Subject: SEAT BELT COMES OUT OF SEAT BELT GUIDE WHEN RETRACTING	Bulletin No: 08-001/17
	Last Issued: 01/03/2017

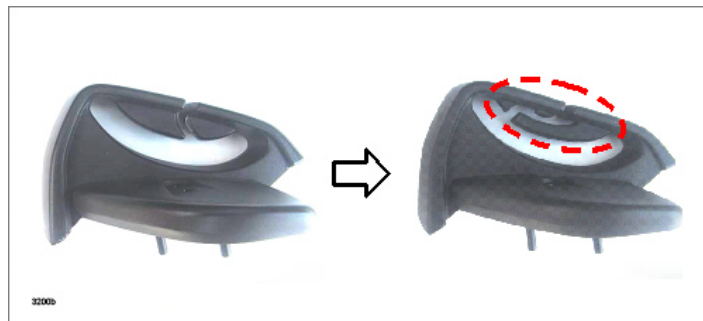
Some customers may complain that the seat belt comes out of the seat belt guide when the seat belt retracts as shown because the shape of the seat belt guide is inadequate.

To correct the problem, the shape of the seat belt guide has been changed.

1. Verify customer concern.
2. Remove two philips head screws on the seat belt guide, then replace the seat belt guide with a modified one (both sides).
3. Verify repair.
